BLYTHE ENERGY PROJECT

**Request for Approval of Third
Insignificant Project Change
(99-AFC-8C)**

**Blythe Energy Project
Transmission Line
Minor Structural Changes, Additional Communications
Systems, and Expanded Work Areas**

November 2008

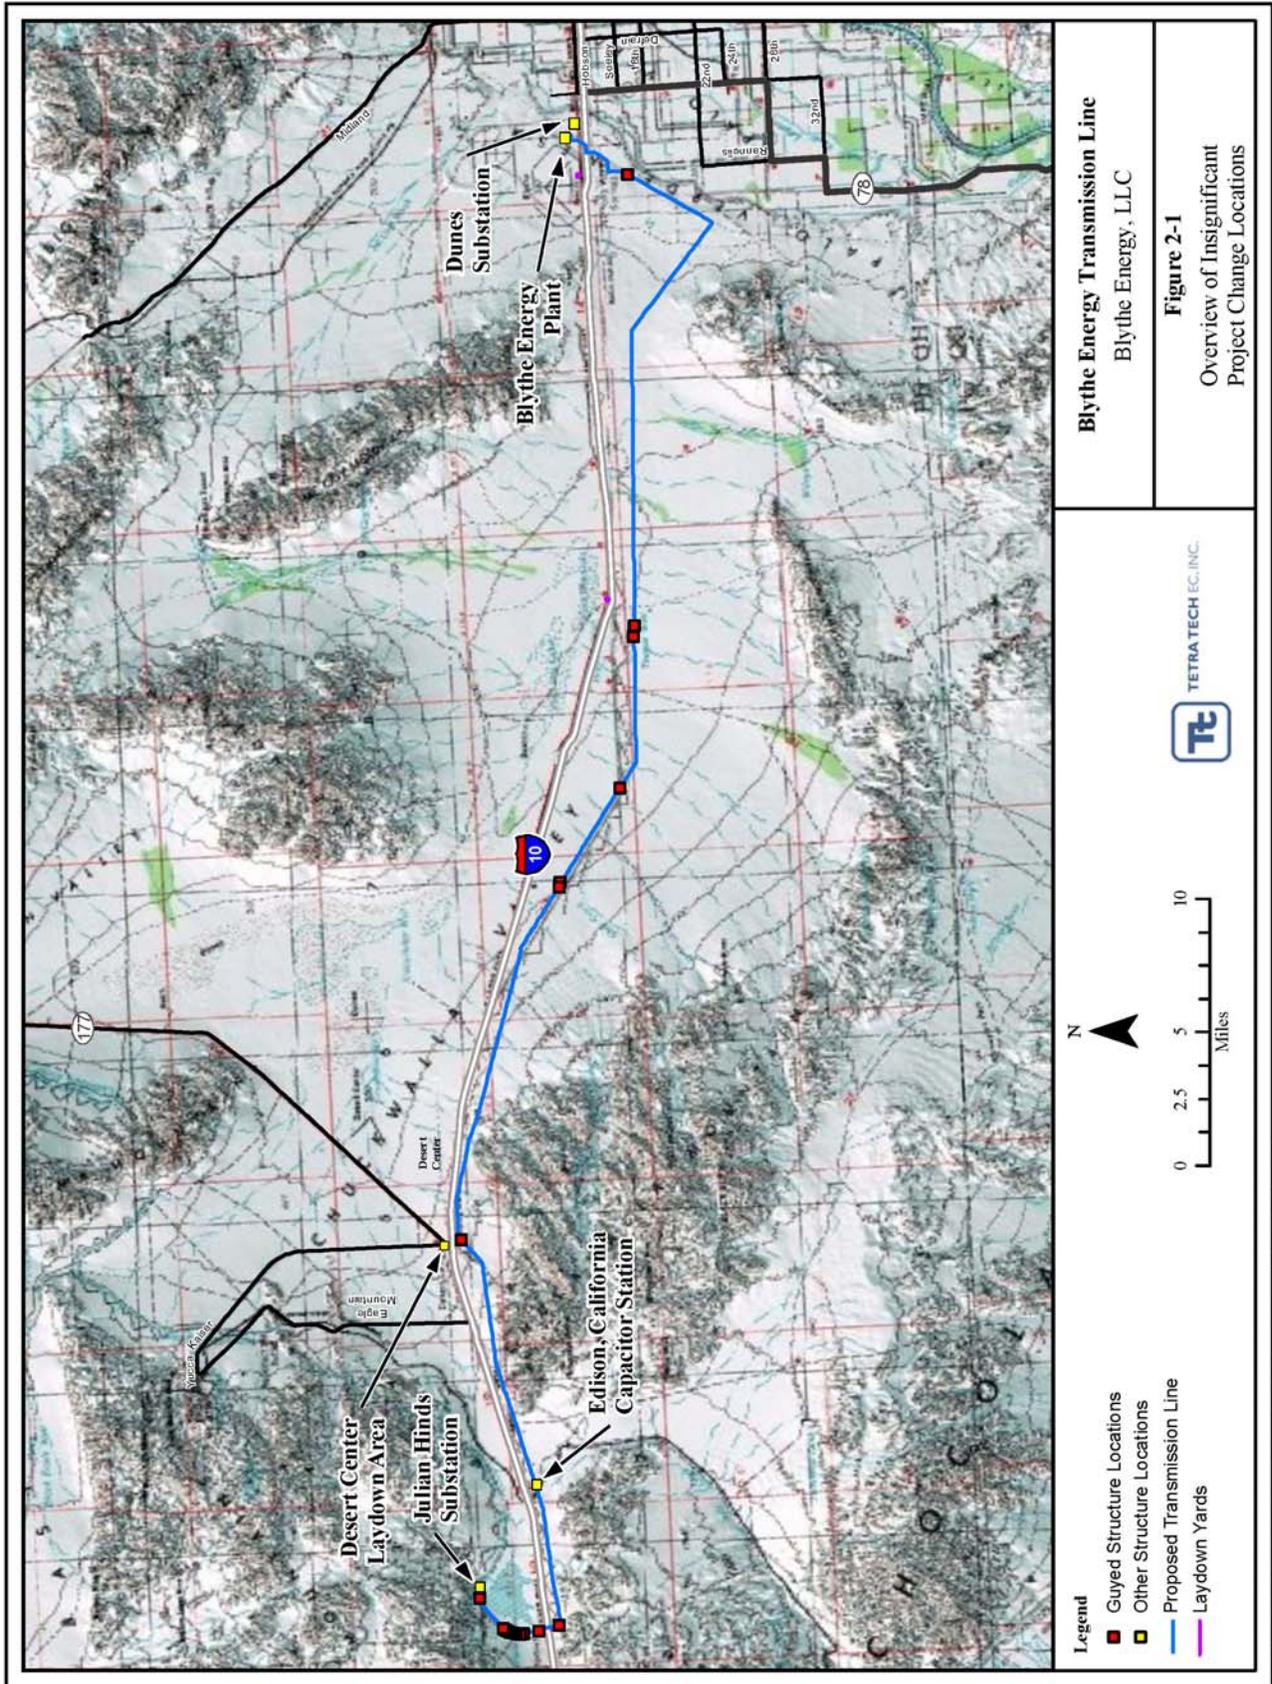
Figure 2-1 illustrates the overall route and the location of the site-specific changes in structure or laydown area location. Table 2-1 summarizes the change in disturbance footprint by proposed insignificant change component. Table 2-2 details the change in underlying land ownership for the various project components between present conditions and proposed changes.

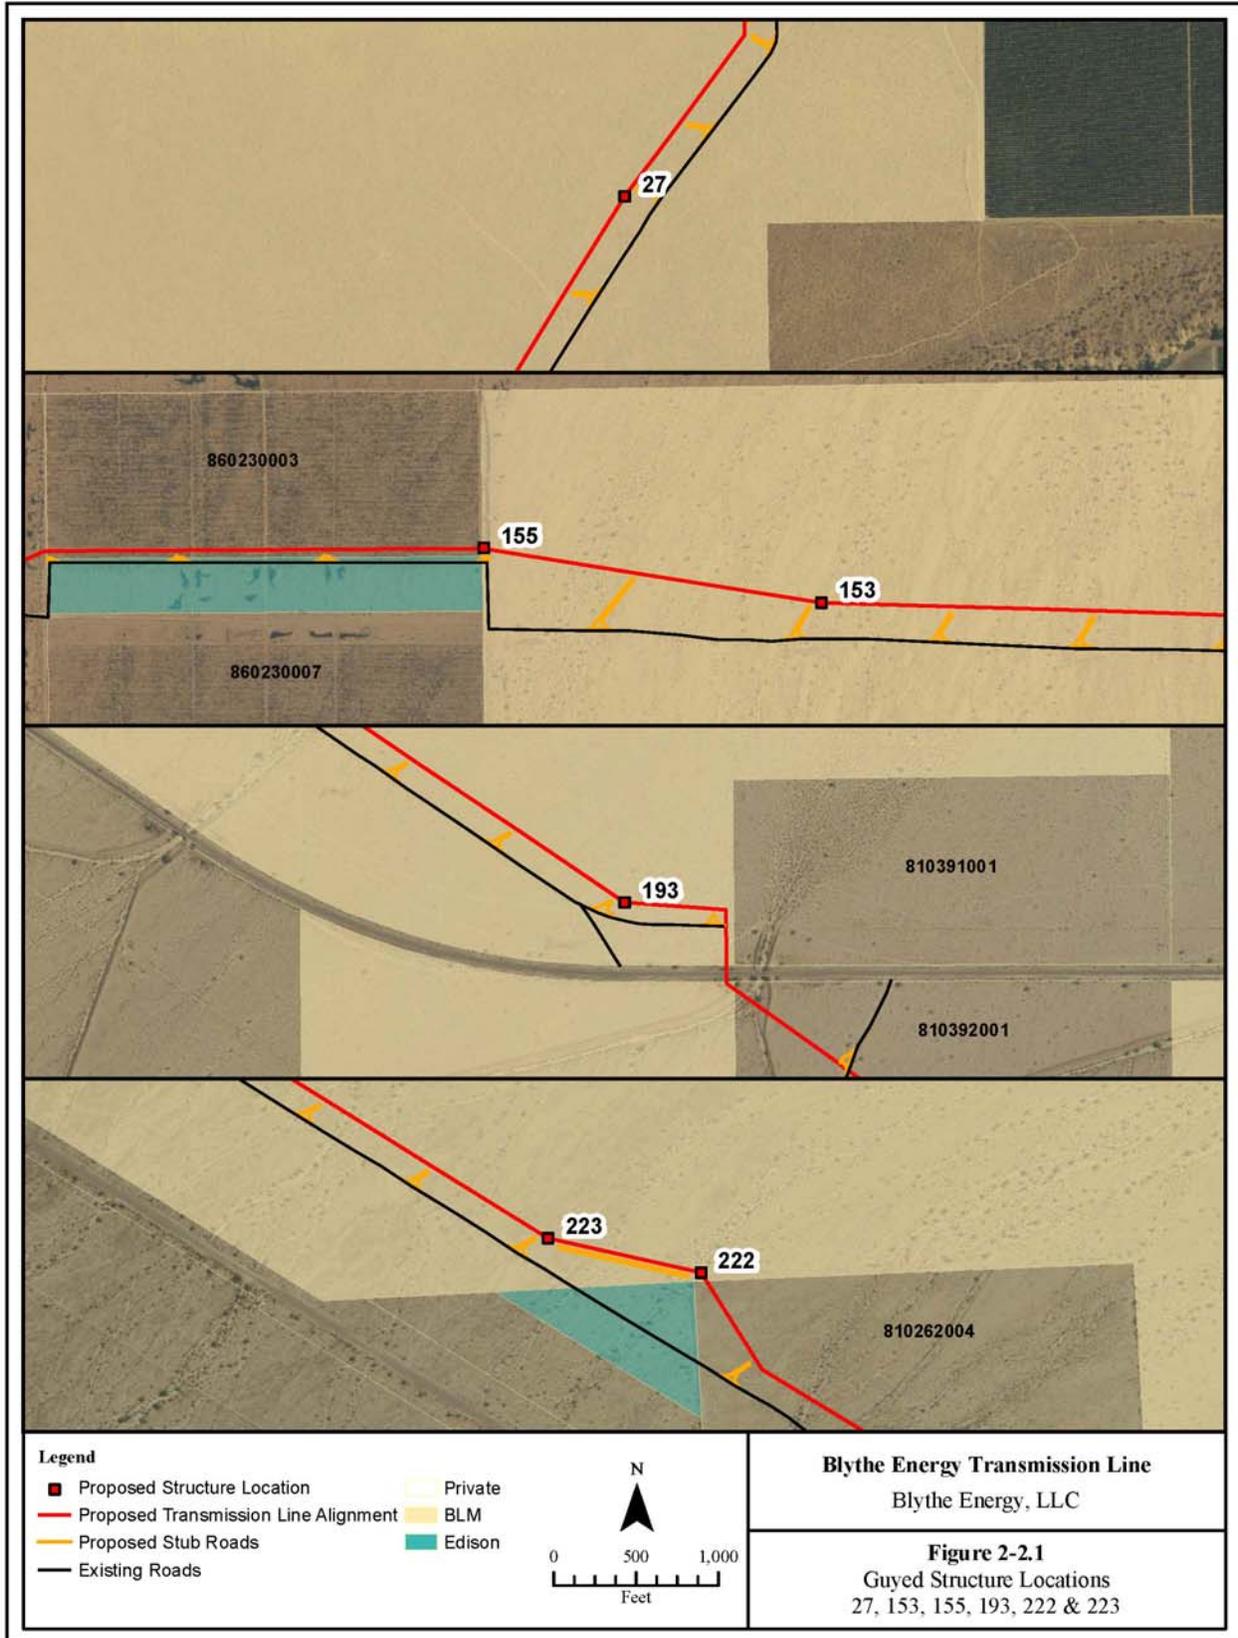
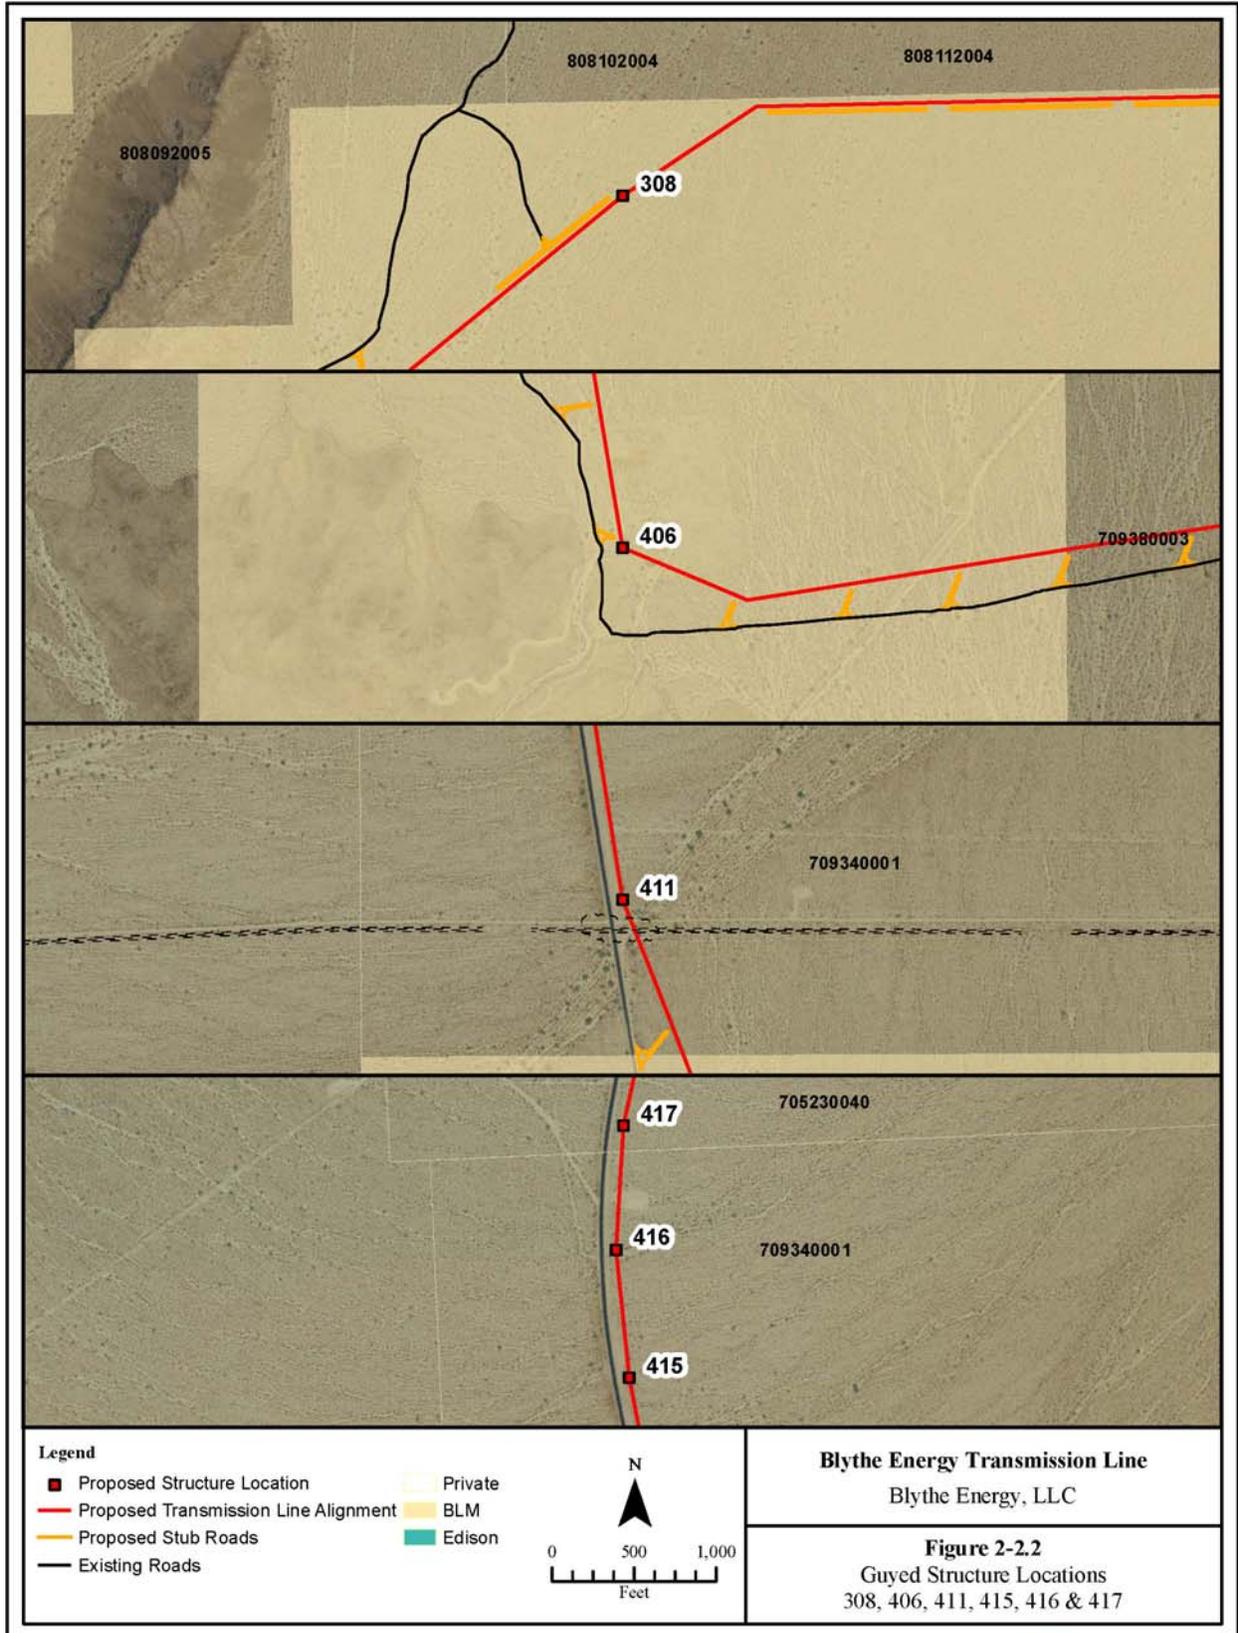
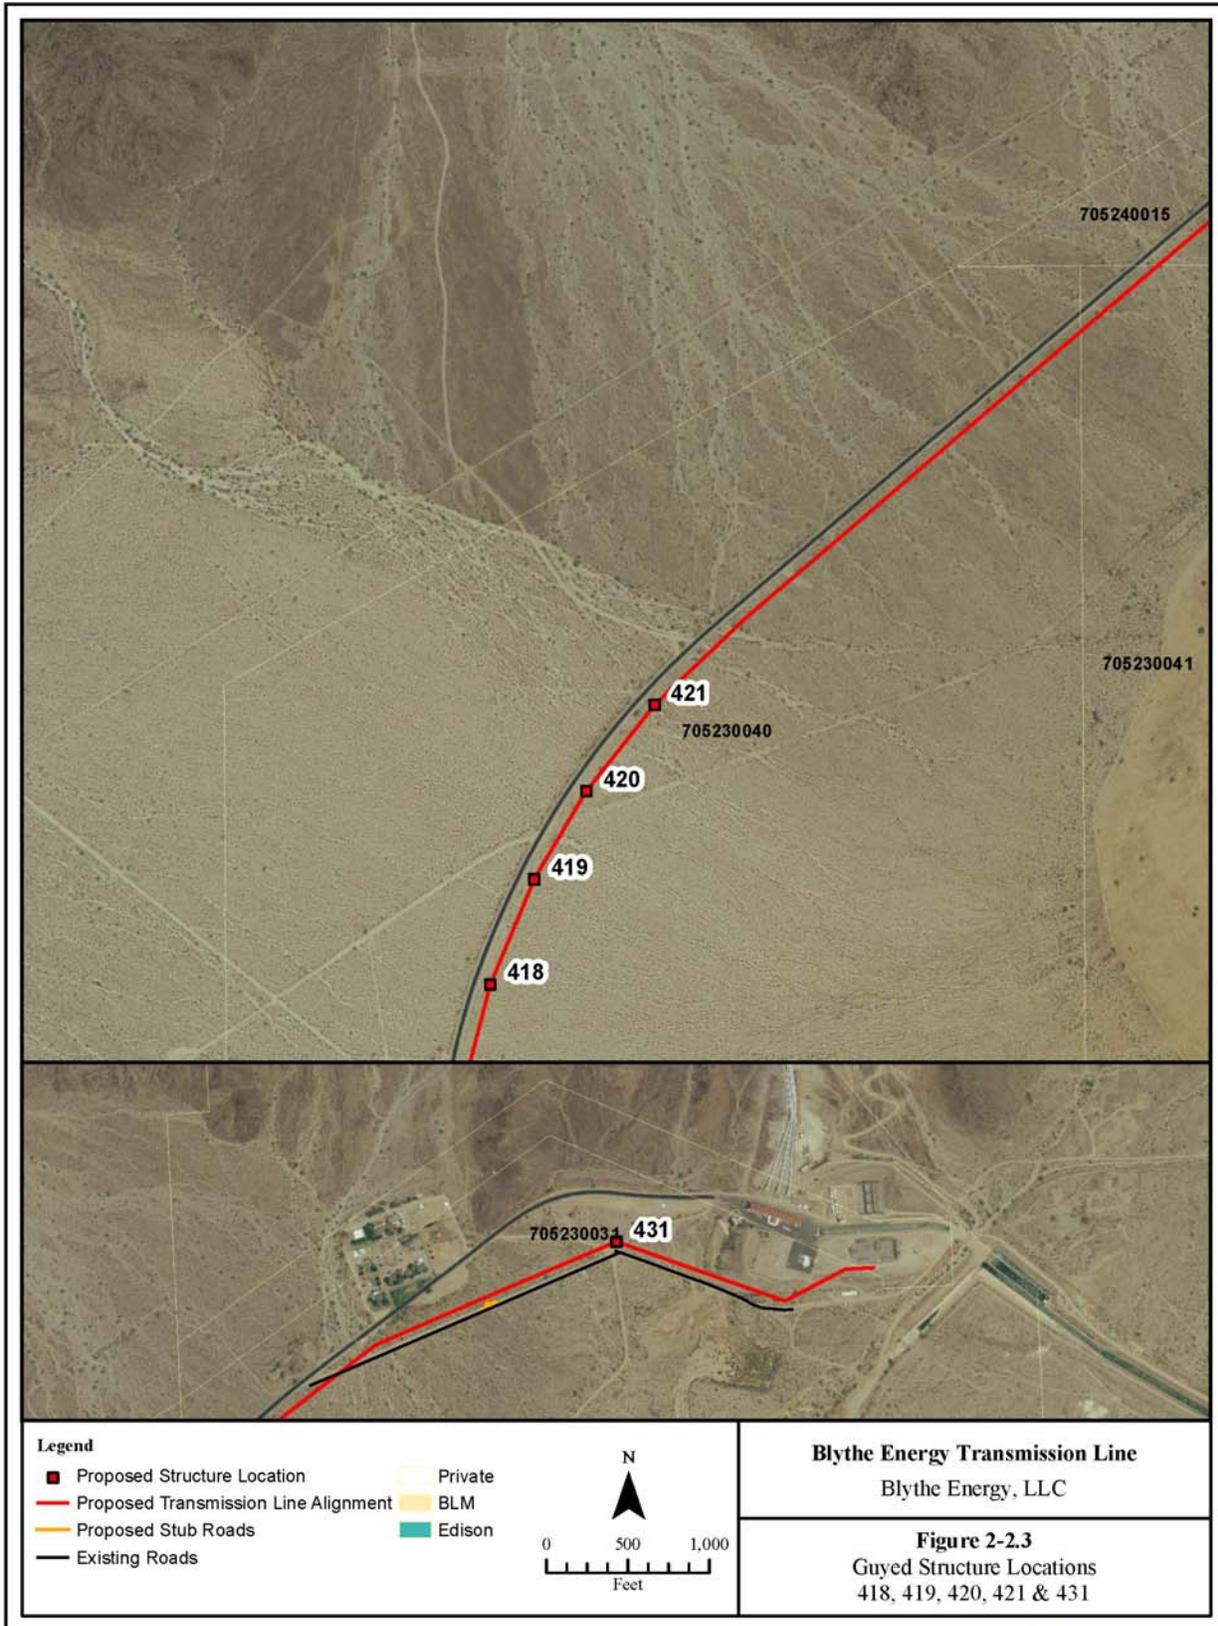
Figure 2-2 is a map of the location of 17 structures that final engineering has determined will require guys to stabilize the structures and to provide for the safety of the public and the reliability of the transmission line. The guy wires, with a diameter of 9/16 inches, extra-high-strength steel, will extend out of the requested 95-foot-wide right-of-way (ROW) by up to 40 feet and averaging around 23 feet. Appendix B contains detailed plan and profile drawings of each of the proposed guyed structures and shows the relationship of the guy wires to the ROW. Note that in no case do the requested guy wires extend beyond the original parcel in which the ROW is located.

The guys are installed by first installing a guy anchor. These anchors are multi-helix shafts that are 10 feet and 7 feet in length. Appendix B also contains specifications from the anchor manufacturing company. The anchors are screwed into the ground with a truck-mounted power auger. They typically reach depths below grade of 8.3 feet and 5.8 feet, respectively. When installed, the anchors will extend horizontally below grade 5.5 feet and 3.9 feet, respectively. If the prescribed torque values cannot be met, then a 20-inch-diameter hole is drilled to match the depth and angle of the anchor. The hole is filled with concrete, and the anchors are screwed into the concrete before it sets.

The extra workspace required to install the anchor will include a one-time track for the drill rig to back up to the guy anchor location and install the anchor, with an assumed width of 12 feet. No new roads or additional clearing will be required, as the trucks can drive over the vegetation if needed. Table B-1 summarizes the requested structures, provides details regarding structure height and angles, and specifies the landowner for each. Table B-2 details the disturbance calculations and their assumptions and includes a summary of the number of guys and guy “runs” along with assumed width and length of disturbance outside the ROW. Appendix B also includes detail plan and profile drawings for each of the guyed structures. The 17 structures and 132 total guy wire “runs” will require a total of less than 0.24 acre of additional disturbance.

The BEPTL consists of both steel and concrete poles. Concrete poles were selected for the tangent (inline poles) with some locations requiring steel pole tangent structures because of access requirements. Most of the angle and dead end locations were specified with guy wires to support the single pole structures. Most of these angle structures are concrete poles. The selection of guyed structures for the BEPTL project was based on economics and schedule concerns. Self-supporting poles that do not require guys cost three to eight times the cost of guyed poles. The line angle and spans dictate the loading and usually the steeper the angle the

At the time of certification, the final design for each of the structures had not been completed. Neither the Application for Certification (AFC) nor the Final Revised Staff Assessment (FSA) specified the support structures for the transmission lines. It is common engineering practice to use guy wires to support transmission structures, especially where turns in the line put substantial lateral stress on the structures. The guyed structures are included in this Insignificant Project Change Request because the final design for the guy wires shows that some of the guys must be installed outside of the previously calculated area for disturbance, adding a very minor amount of disturbance to the overall calculations. While the vast majority of the structures are self-supporting, these 17 structures, representing less than 5 percent of the overall set of structures for the Project, will need to be guyed as determined by final engineering design.

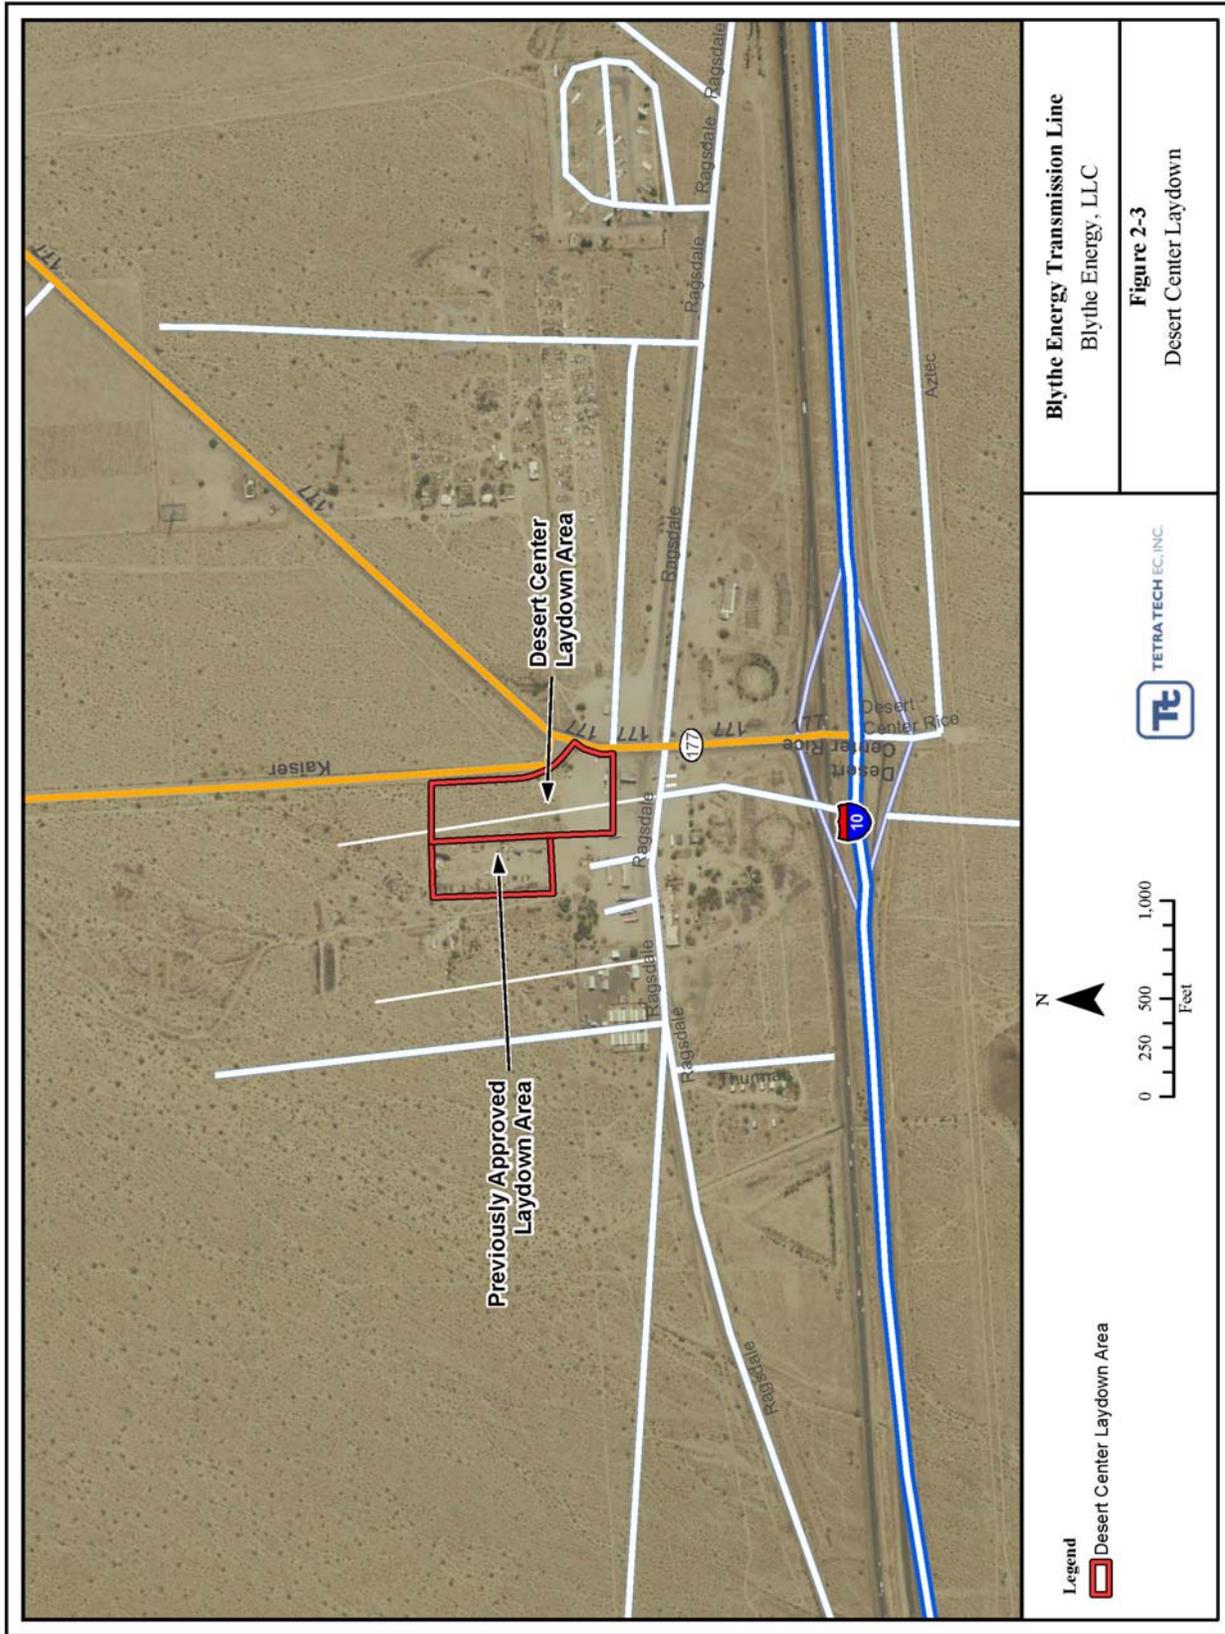
Figure 2-3 illustrates the proposed Desert Center laydown area expansion. The landowners (the Ragsdale family) have given permission for the expansion. The laydown yard will be expanded to approximately 10 acres and will be fenced with both chain link fence and desert tortoise fencing. A biologist will be on-site during fence installation to conduct a pre-construction sweep of the area and to ensure that no tortoises are trapped inside the fence. The area will be cleaned up as specified by the landowner after construction is complete.
